# Access Compliance Report

## Public Rights-of-Way

Intersection ID: 47019	Main Street: TRIBUNE_DR	Cross Street: MARKHAM_WOODS_CT	Location: N
ADA ID: 48B318D82A61	Ramp Type: Perp	Initial Pass/Fail: Fail	Overall Compliance: No
			Severity Score: 21.25

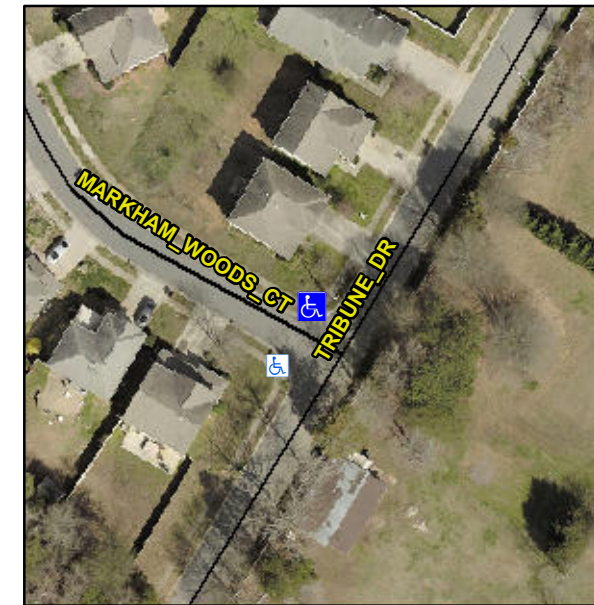
**Not Found, R304.5.1, R304.5.3**

Compliance	Description	Data	Compliance	Description	Data
N/A	Ramp Length (in)	46.5	Yes	Ramp Slope (%)	8.1
No	Ramp Width (in)	46.5	No	Ramp XSlope (%)	5.5
N/A	Flare Type LT	N/A	N/A	Flare Type RT	N/A
N/A	Flare Slope LT (%)	N/A	N/A	Flare Slope RT (%)	N/A
N/A	Flare Traversable LT?	N/A	N/A	Flare Traversable RT?	N/A
N/A	Landing Length (in)	N/A	N/A	DWS Provided?	N/A
N/A	Landing Width (in)	N/A	N/A	DWS Contrast?	N/A
N/A	Landing Slope (%)	N/A	N/A	DWS Length (in)	N/A
N/A	Landing X Slope (%)	N/A	N/A	DWS Full Width?	N/A
N/A	Landing Curb? (Y/N)	N/A	N/A	DWS Offset (in)	N/A
N/A	Shared Landing?	N/A			
N/A	Gutter Ponding?	N/A	N/A	Gutter Slope (%)	N/A
N/A	Gutter Lip Ht (in)	N/A	N/A	Gutter X Slope (%)	N/A
N/A	Painted X Walk1?	No	N/A	Painted X Walk2?	N/A
	X Walk 1 Direction	To SW		X Walk 2 Direction	N/A
N/A	X Walk 1 Width (in)	N/A	N/A	X Walk 2 Width (in)	N/A
	X Walk 1 Slope (%)	0.9		X Walk 2 Slope (%)	N/A
	X Walk 1 X Slope (%)	4.5		X Walk 2 X Slope (%)	N/A

**Remove & Replace Entire Ramp.**
